Tuesday, July 12, 2022 Medway Planning and Economic Development Board 155 Village Street Medway, MA 02053

<u>Public Briefing Continuation - BRIGHTPATH CHILD CARE CENTER</u> SITE PLAN - 67 C MAIN STREET:

<u>Public Hearing Continuation – PHYTOPIA Site Plan, Reduced Parking Special Permit and Groundwater Protection Special Permit</u>

Public Briefing - Master's Touch Minor Site Plan-83 Main Street:

C5.0

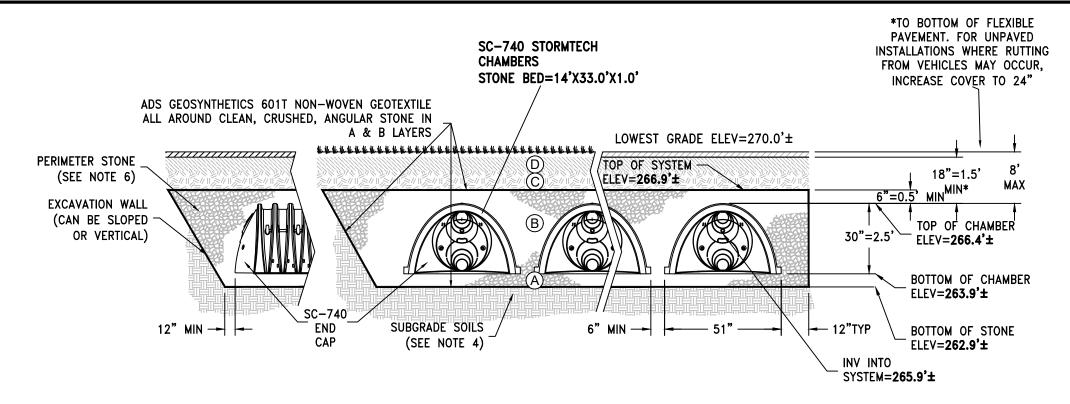
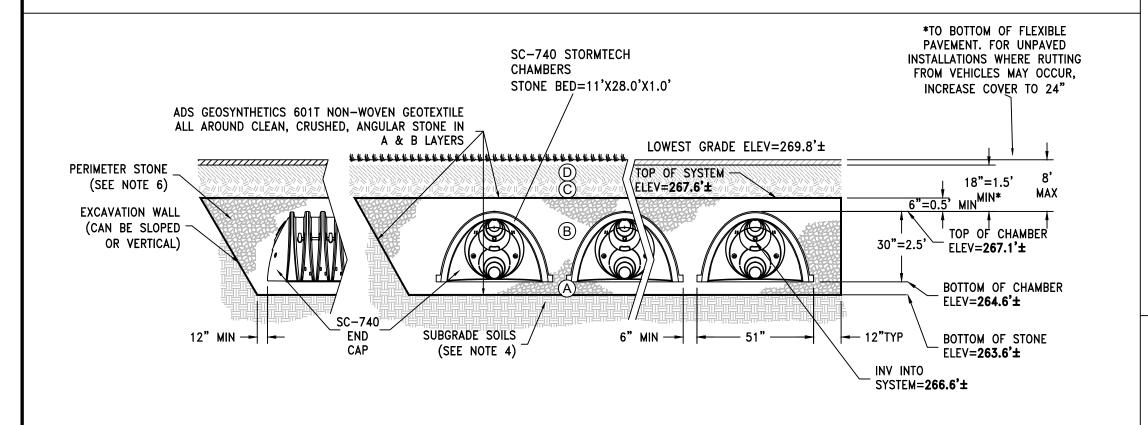
See attached complete version of the plan set. In particular, look at Sheet C5 Civil Plan.

- 2. The Plans do not include the building elevations as required. Regulations require all plans to be bound in one set. (Ch. 200 §205-4 [§204-4.D])
- 3. The Civil Plan (Sheet C5.0) has not been stamped. Additionally, there are no PEDB signature blocks or Town Clerk no appeal certification language on any of the sheets. (Ch. 200 §205-4 [§204-4.E])
